Product Change Notification

Product Group: Vishay Dale/April 24, 2019/PCN-DI-00446-2019 Rev 0

Marking Change on the SM Series Connectors

Figure #1: SM Mating Configuration

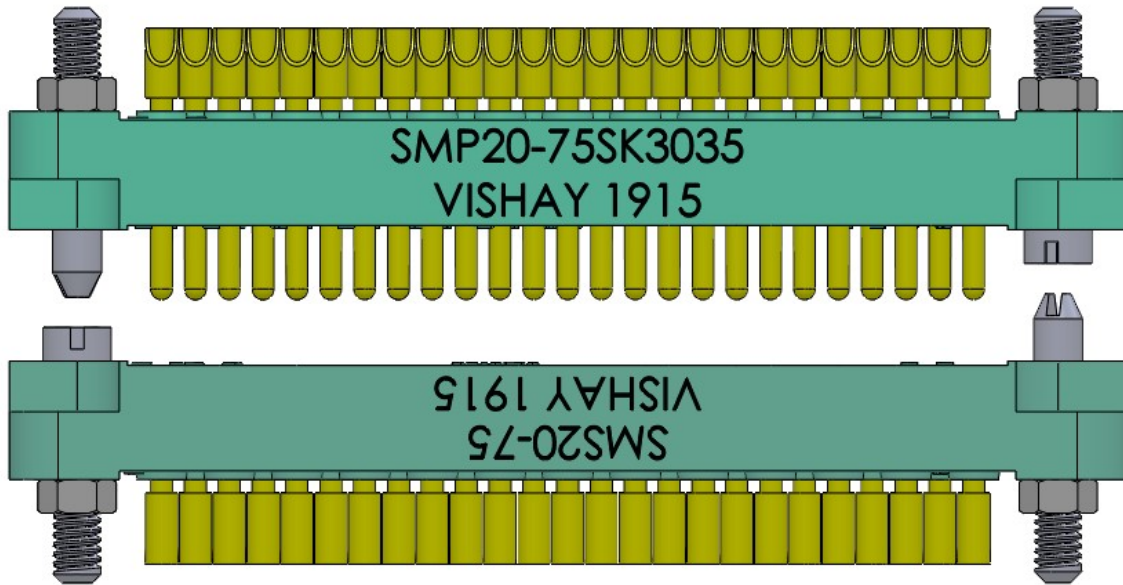
DESCRIPTION OF CHANGE: The Vishay SM Series Connectors will immediately update the marking method to laser marking with alternate method of ink stamping. Print Orientation on parts will also be updated.

REASON FOR CHANGE: Vishay is now capable of laser marking and will add this method as an equivalent print method to the ink marking. Due to this, Vishay will also be updating the orientation of the print on the parts. See example figures below.

PRODUCT IDENTIFICATION: Product will show laser marking as primary method. Product's Marking will be oriented differently as shown in figures below.
